SUBJECT: Virgil C. Summer Nuclear Station
Docket No. 50/395
Operating License No. NPF-12
Relief and Safety Valves
NUREG-0737, II.D.1

Please find attached the South Carolina Electric & Gas Company (SCE&G) response to NRC questions dealing with NUREG 0737, item II.D.1. These question responses have been structured to provide the most concise and applicable answers to the NRC specific requests on the original submittal.

RESPONSES TO SAFETY EVALUATION QUESTIONS
TMI ACTION NUREG-0737 II.D.1
FOR V. C. SUMMER UNIT 1

FIGURE A-3
 FORLING FUNCTION PROCESSOR
 VERIFICATION PROBLEM

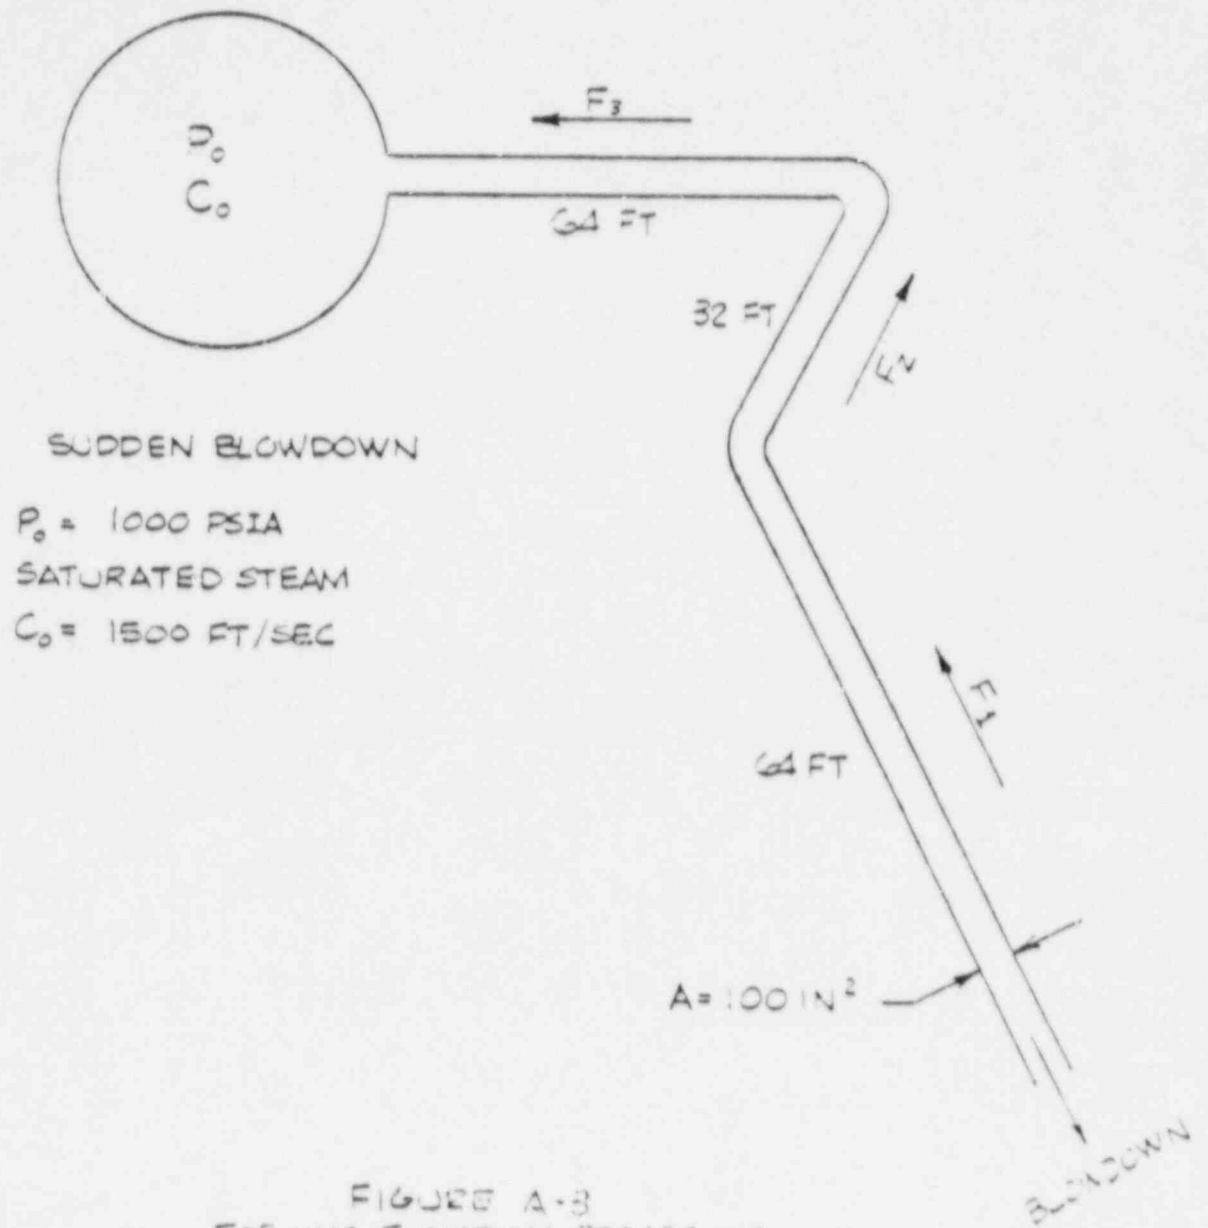
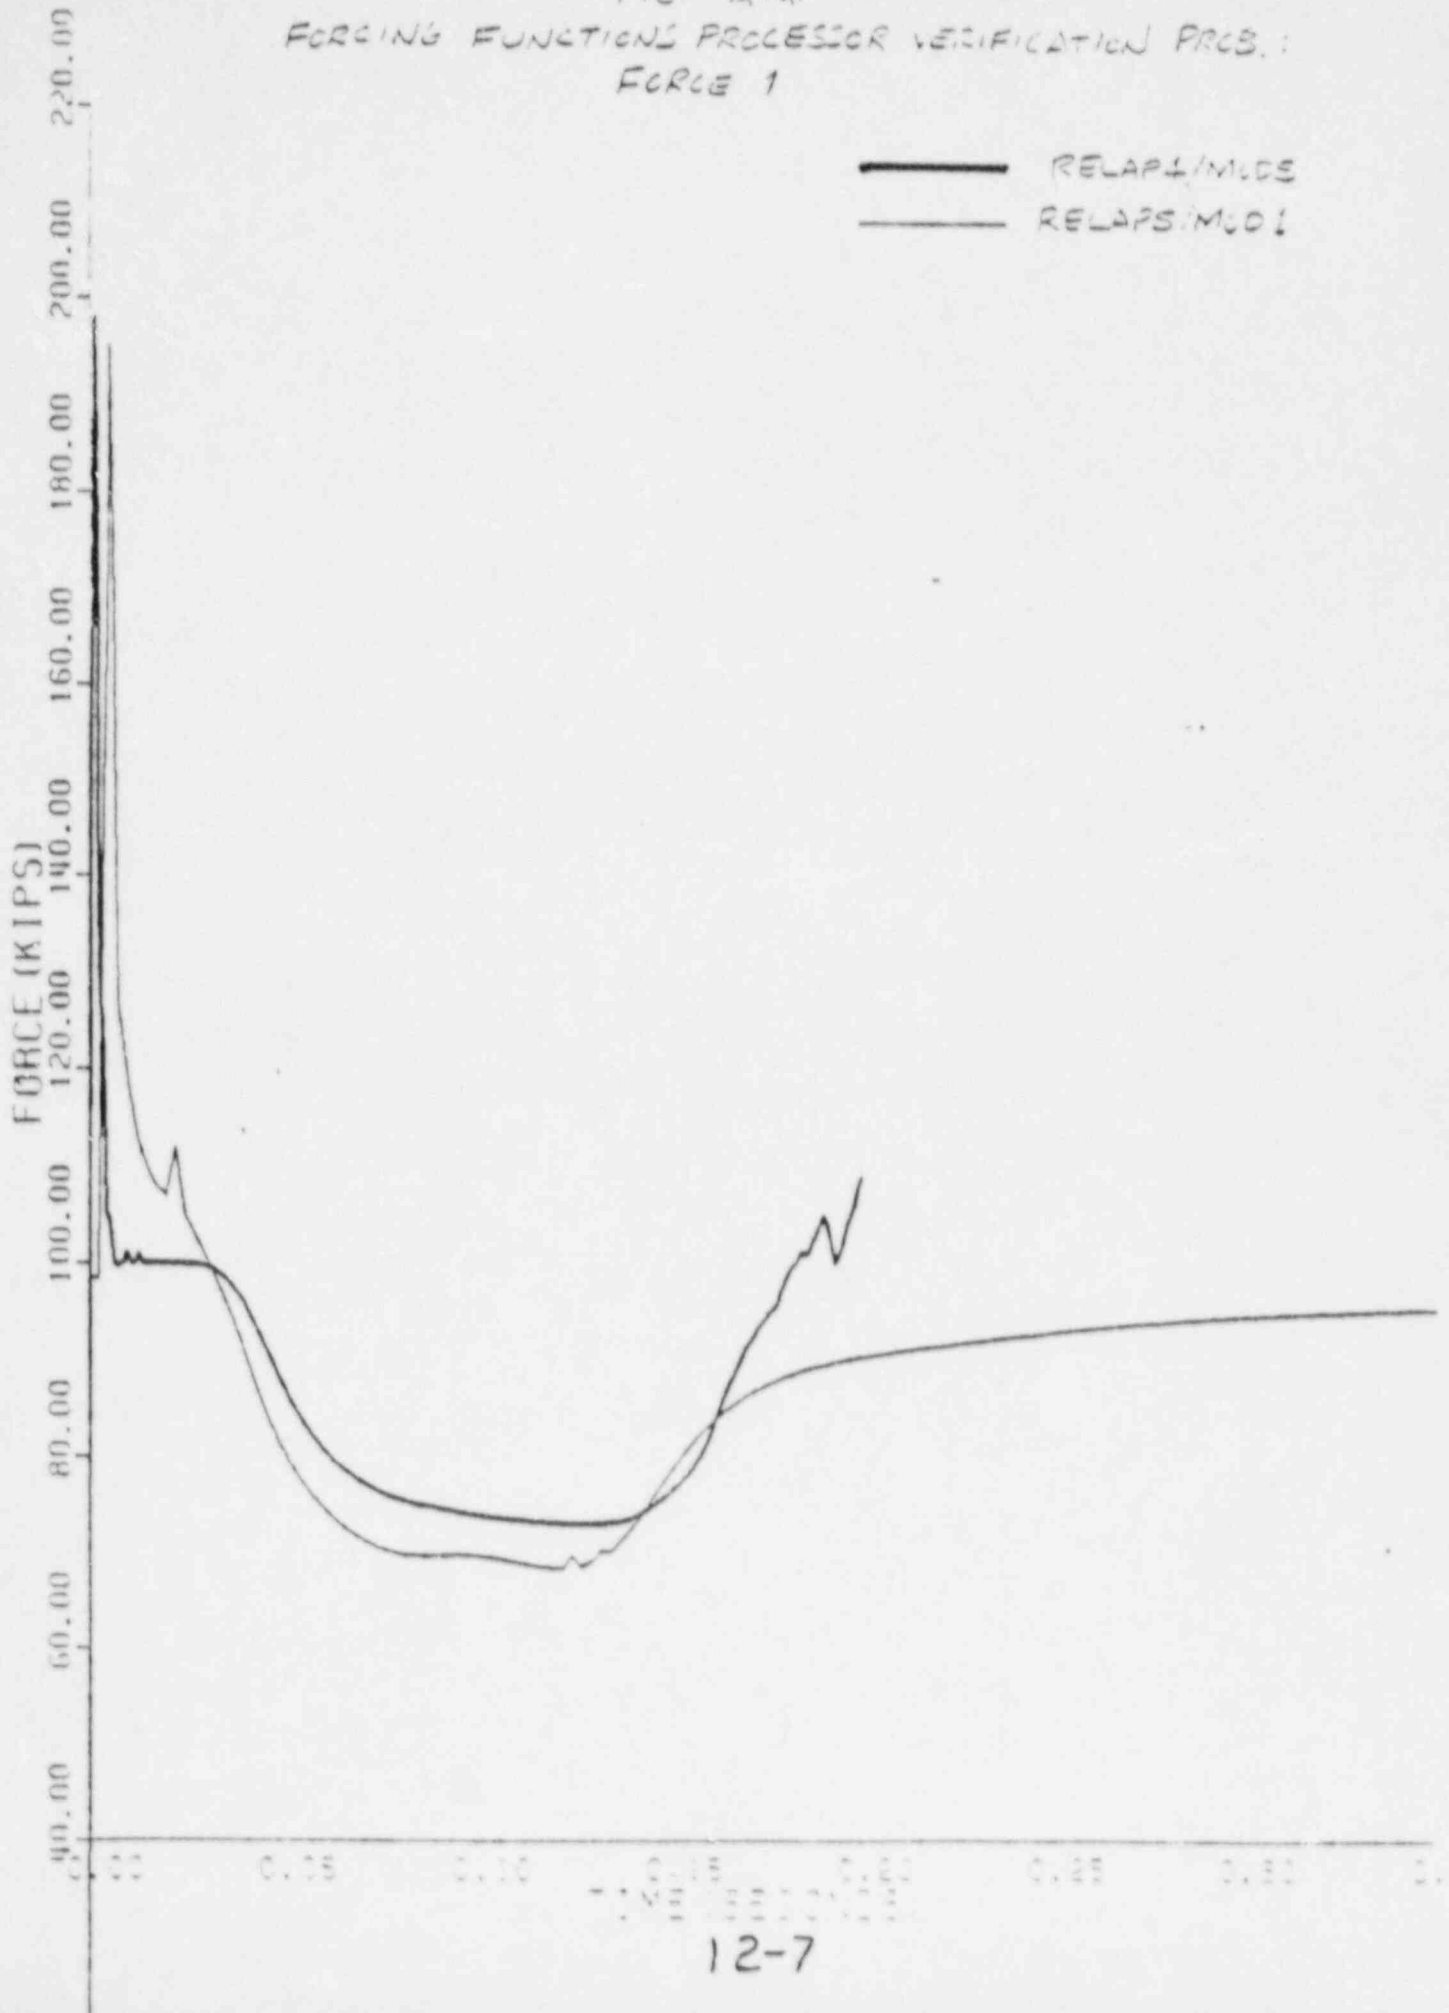
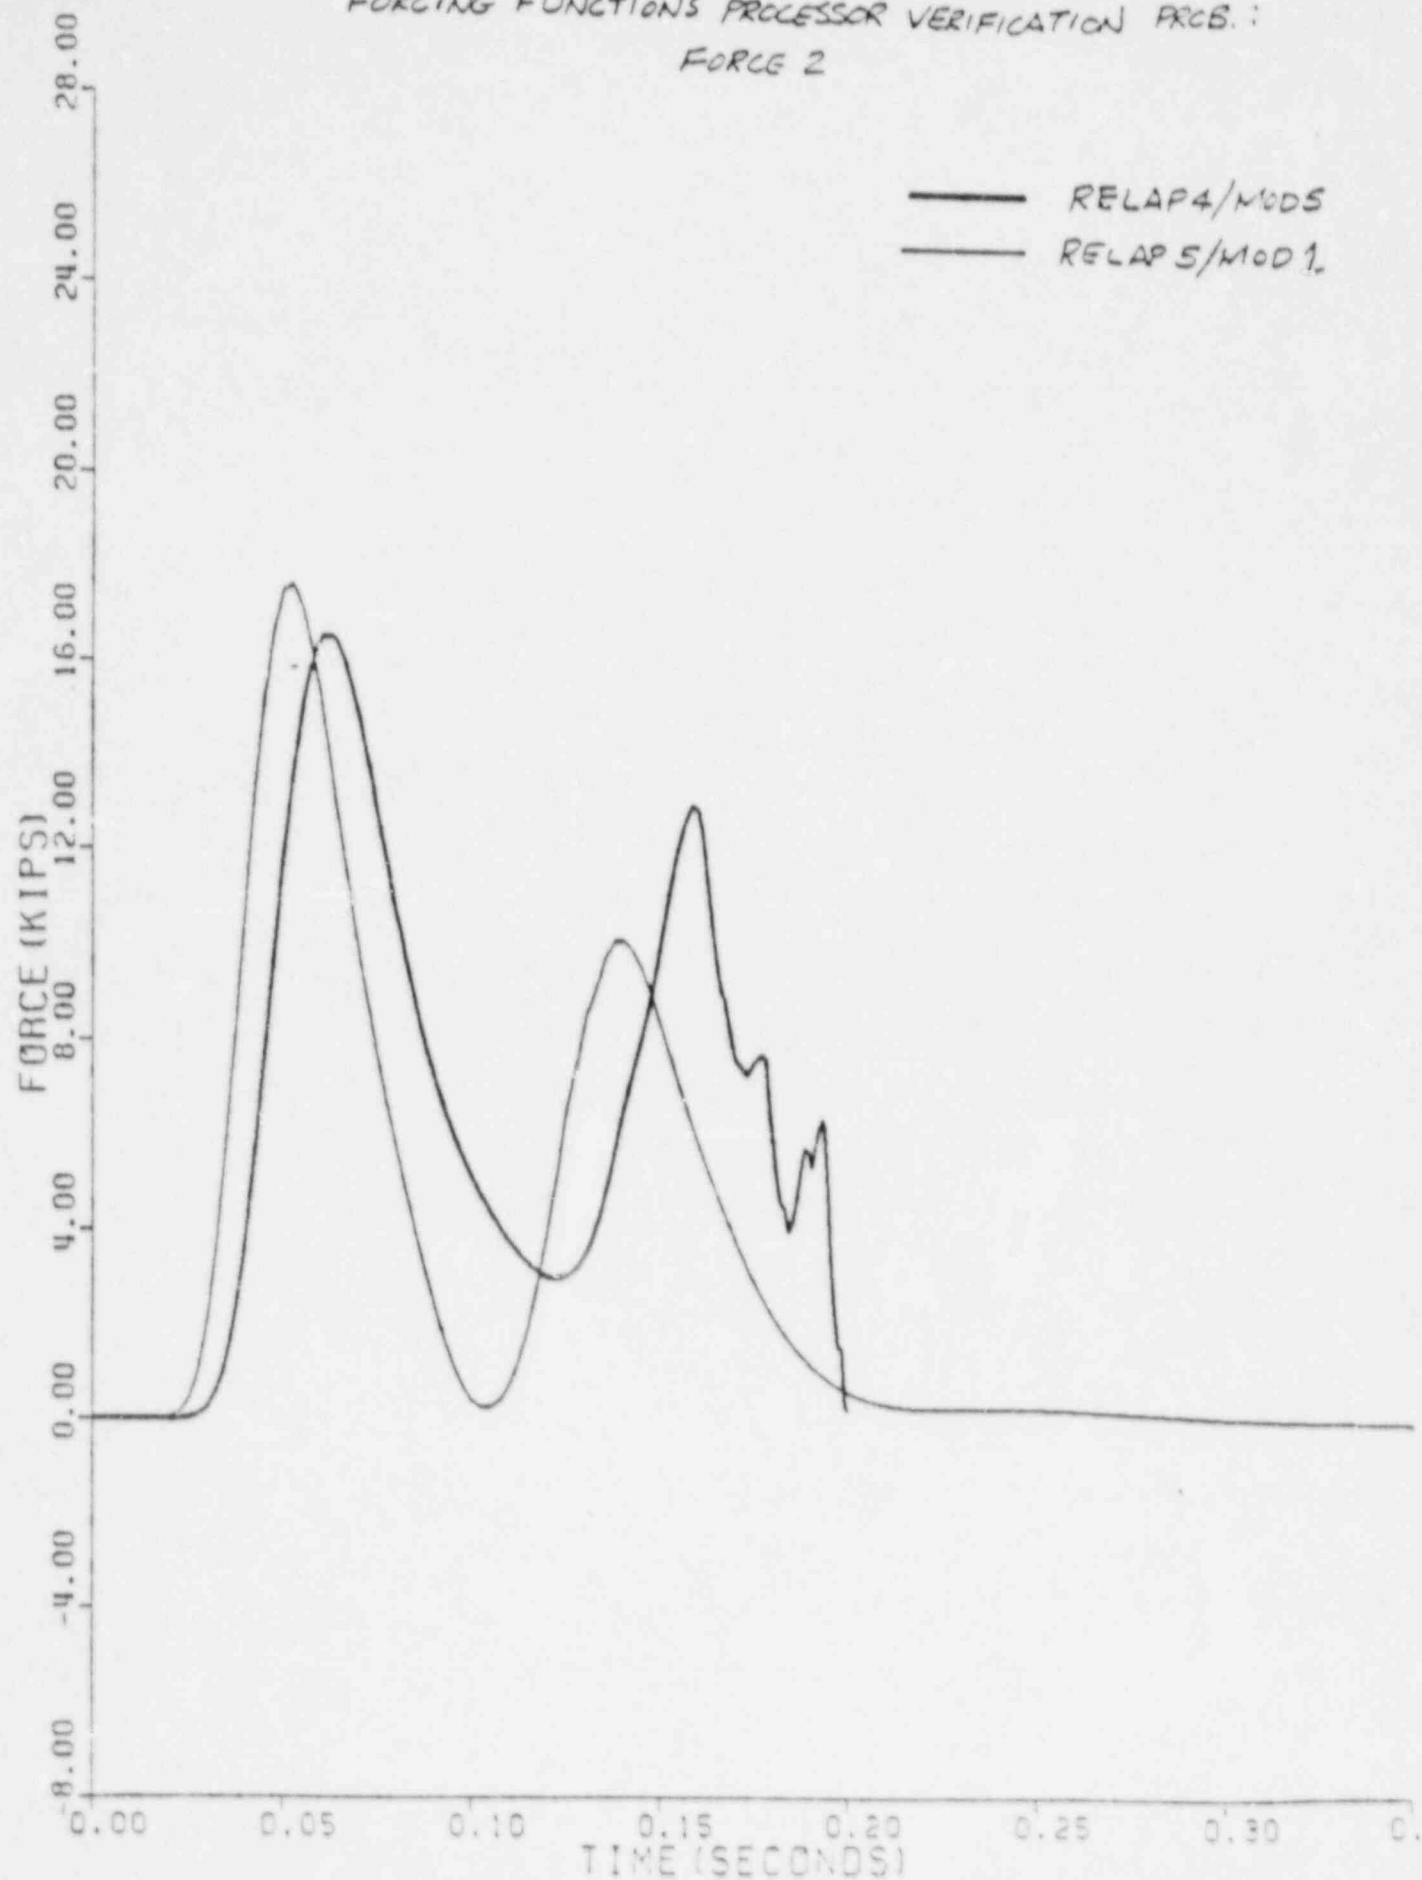
The submittal states that the thermal hydraulic analysis was performed using RELAP 5/MOD1 and that the RELAP 5 control system was used to calculate the fluid forces. Identify the methodology used to calculate forces from RELAP 5/MOD1 and provide additional verification that the methodology produces accurate force histories for similar problems.

Gilbert Associates, Inc. has developed a RELAP5/MOD1 processor for the evaluation of equations A-5 and A-6. This methodology has been verified by analyzing the steam line rupture given in Figure 3-3 which has also been analyzed by Moody², Strong and Baschiere³, and Burke and Webb⁴. Figures A-4, A-5, and A-6 compare the results of the analysis using RELAP5/MOD1 with answers reported previously by Burke and Webb⁴. The magnitude and timing of the forces compare favorably. The small differences seen are probably due to the inclusion of friction in the RELAP5/MOD1 model, which was not included in the other calculations.
